Aurizon Network's revised GAPE DAAU

RTCA response to QR Network's proposed GAPE reference tariff DAAU

Submission in response to QR Network's proposed
DAAU in relation to a GAPE reference tariff

Figure 1: An alternative relationship between GTK & AT1 rates approved for UT3

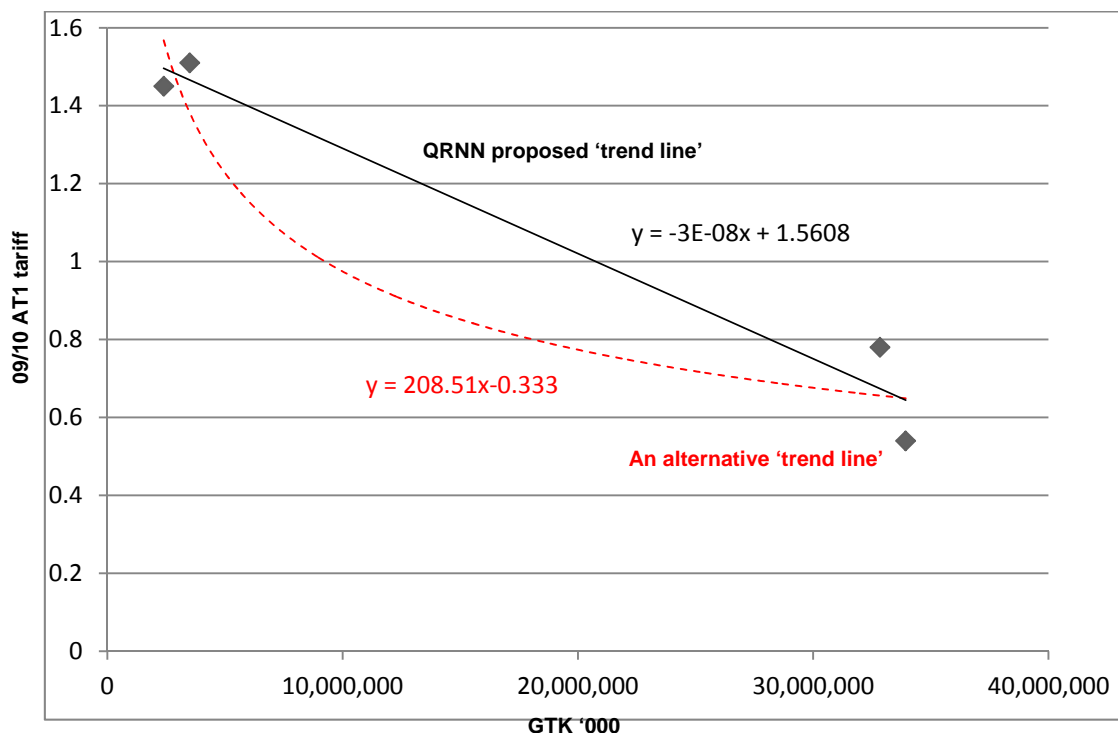
The volume adjustment proposed by QRNN is also overly simplistic. QRNN assumes a simple linear relationship between volumes and maintenance costs, without providing any justification for this assumption. This is illustrated in Figure 5 of the QRNN submission.

The assumption of a linear relationship between volume and costs has a very significant impact on the estimate of incremental maintenance costs. If a non-linear relationship is assumed (as in Figure 1 below), the estimate of maintenance costs per '000gk falls from \$1.22 (as estimated by QRNN) to well below \$1.

RTCA submits that maintenance costs to be included in GAPE reference tariffs cannot simply be inferred from costs associated with brownfield railways, assuming a simple linear relationship between costs and volume (particularly given the very limited number of data points from which to derive any such relationship).
